# **YUCCA MOUNTAIN SITE CHARACTERIZATION PROJECT**

## **Report of the Peer Review Panel on the Early Site Suitability Evaluation of the Potential Repository Site at Yucca Mountain, Nevada**

**January 1992**

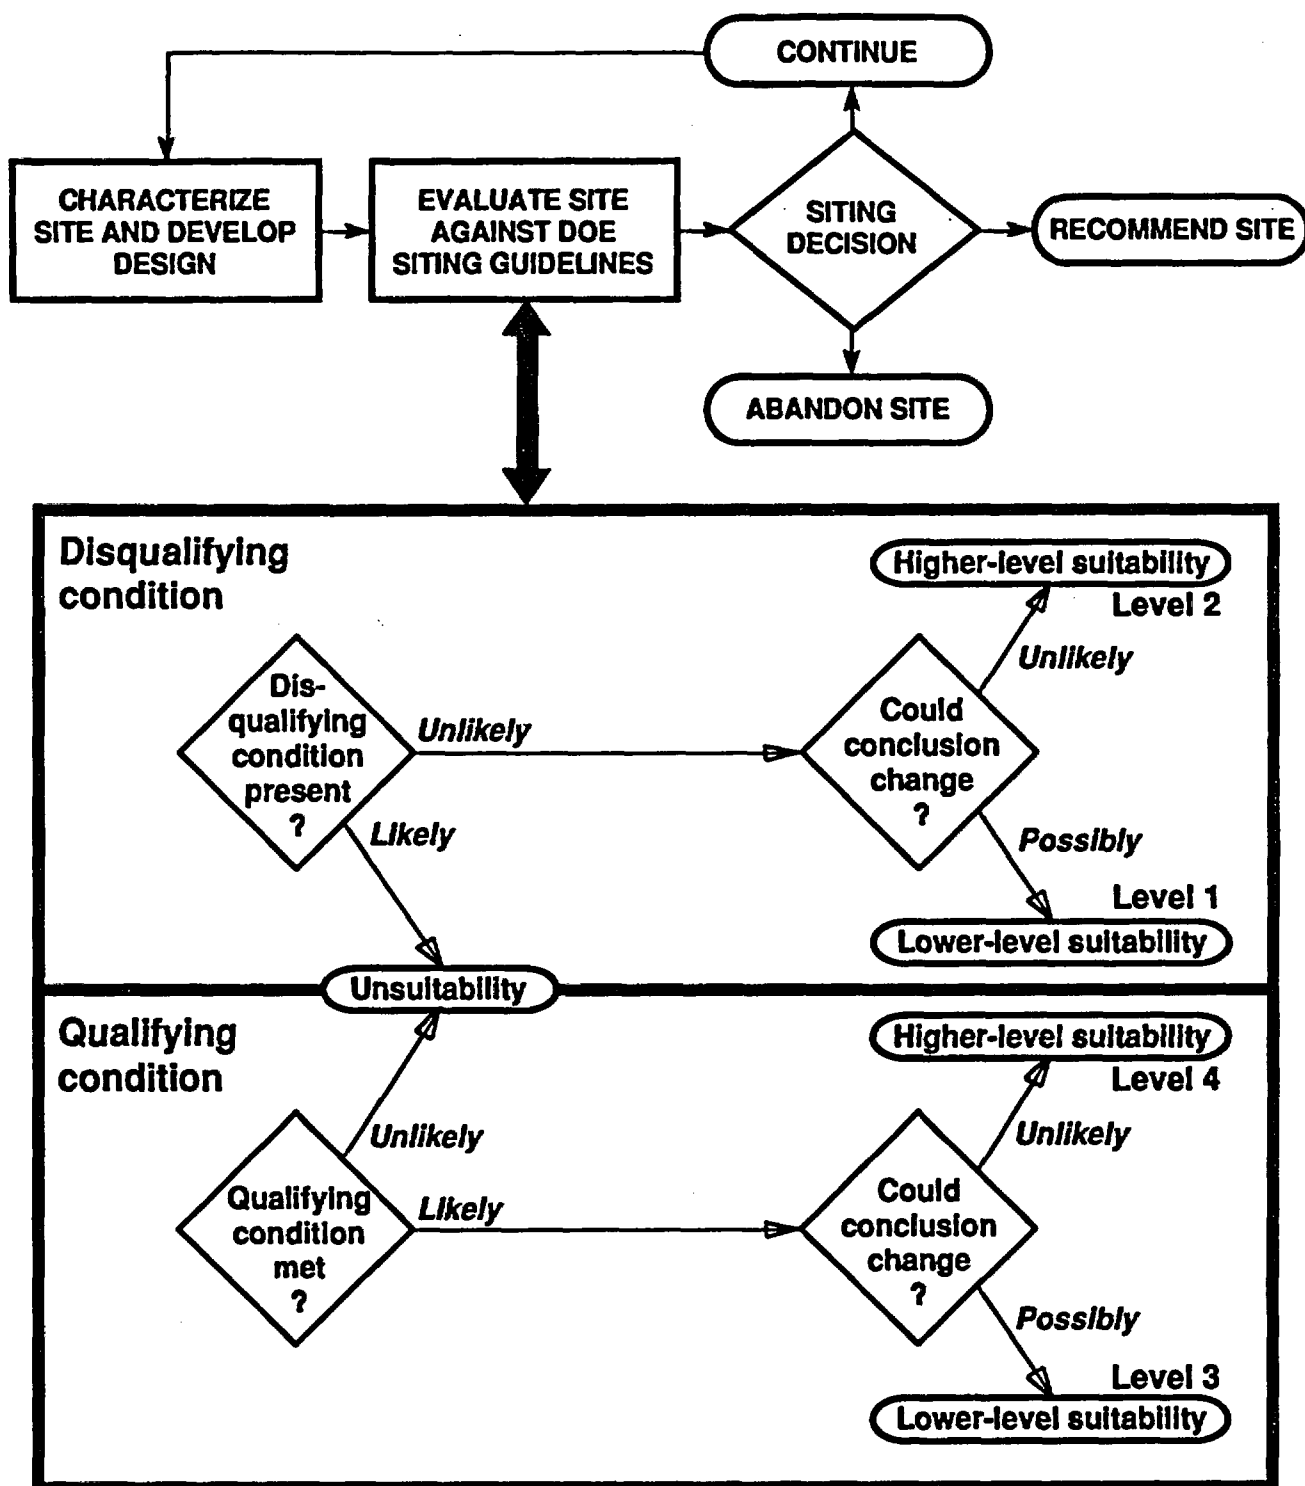
| 4. Organization <u>Brigham Young University</u> | 8. Paragraph <u>Figure 1-2</u>            |

On the disqualifying condition portion where you ask if the conclusion could change, I would substitute "possibly" for "likely." You really don't believe the conclusion will change but, because it possibly could, additional data are called for.

The reviewer makes a good point, which was also made in Dr. Hodges' Comment #2. The figure and its caption will be changed as shown on the attached figure (will be Figure 1-3).

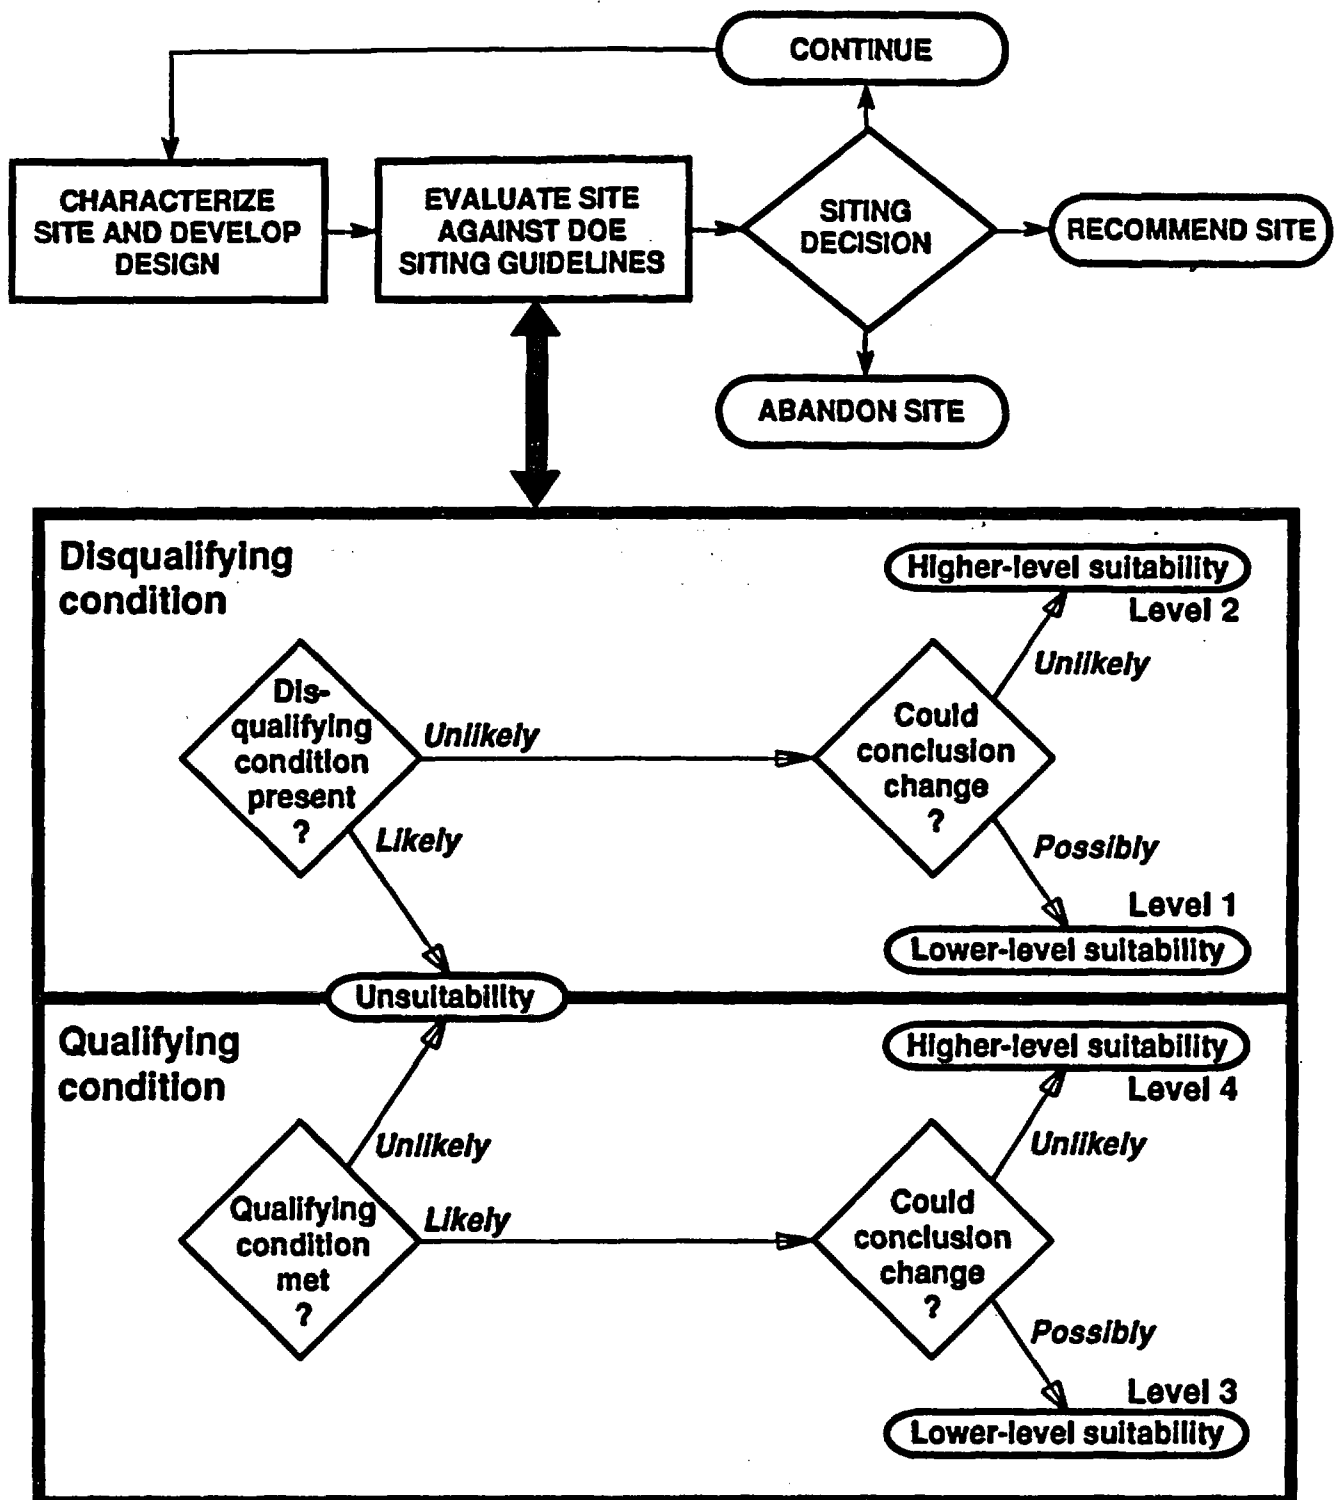
8. Paragraph Figure 1-2

I think it likely that a casual reader will be confused by your stated distinction between higher-level and lower-level suitability. I understand and agree with your criteria, but many readers may not. You state in the caption for Figure 1-2 that "the primary distinction between higher-level and lower-level findings is the likelihood that further information will change conclusions about the suitability of the site...". (The italics are mine). Consider the faulty line of reasoning that could arise from this statement. If a lower-level suitability finding for a disqualifying condition means that it is unlikely that the disqualifying condition is present in light of existing data but that it is likely that "further information will change conclusions about the suitability of the site", then doesn't this mean that you fully expect future data to establish the disqualifying condition for the site? The confused reader may reasonably ask why you are reluctant to say simply that you expect the disqualifying condition to be met? What are you trying to hide?

Dr. Hodges makes a good point, which was also made in Dr. Albrecht's Comment #1. The figure and its caption will be changed as shown on the attached figure (will be Figure 1-3).
